HP 9836 A and C CPU Board 0926-66516
Config Jumpers to adapt 27c 256 Boot rom's

Tracks seen circuit Side

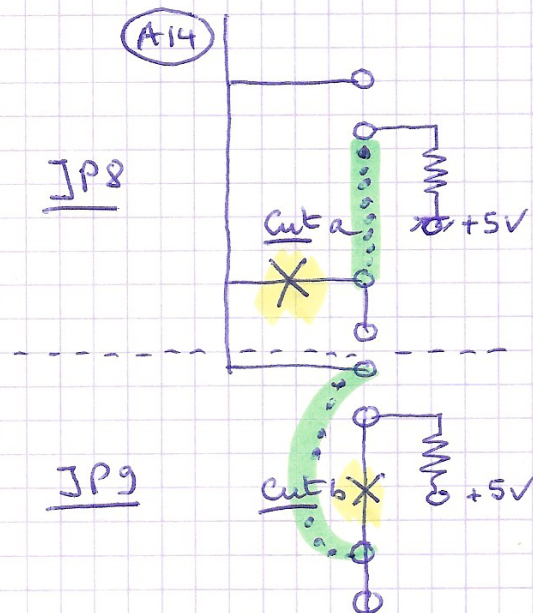
⚠ The original Rom U 88 1818 - 3115
U 57 1818 - 3114

have not the same pin-out as the 27c 256
To replace ROM by UV Rom 27c 256 the
Jumpers have to be configured as follow =

- ① Cut the tracks (a+b)
- ② Solder Straps 1 and 2
- ③ Install the 2 x 27c 256 programmed with the rom's files.
